LOT #311

PATHWAYS - PHASE 2

KLONDIKE

BASEMENT APARTMENT - 2 BDRM

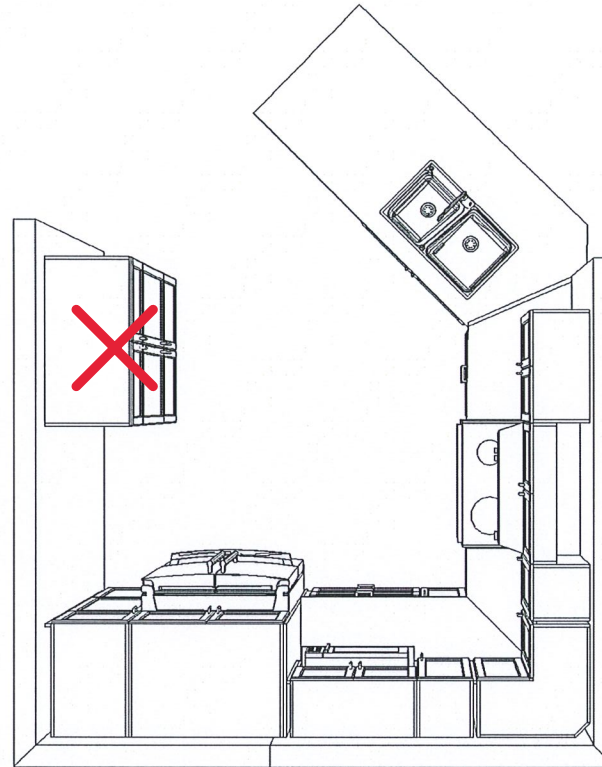
MOUNTING HEIGHT -96
39" UPPERS @ 21" ABOVE COUNTER
~~LIGHT VALANCE~~

BASEMENT VANITY - 3D VIEW

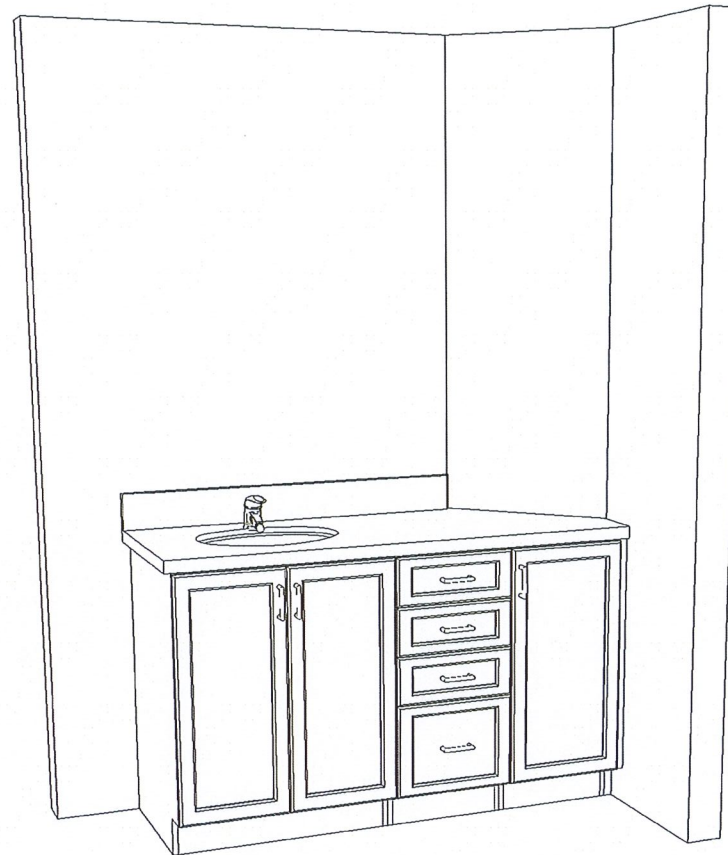
~~NOTE: HEIGHT INCREASED TO 36"H~~
